**MOTOROLA**

RE: Pending modification to FCC ID LX698FC4007

We are requesting you to reconsider the dismissal of our application for the permissive change for the following reasons.

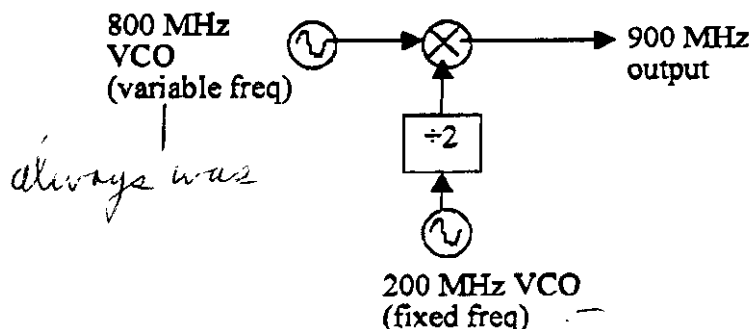
The subject Transmitter consists of two VCO's as shown in the block diagram below.

The basic frequency determining VCO was not changed. The 200 MHz VCO originally used was made obsolete by the vendor, thereby requiring a new VCO. A new VCO with similar performance specification was chosen to replace the obsolete part. Note that all other circuitry, such as the frequency determining VCO, both synthesizers, mixer, and divider circuitry were **NOT** changed. Any change in the frequency of the subject transmitter is performed by changing the frequency of the 800 MHz VCO, and **this has not changed** from the original design. *A*
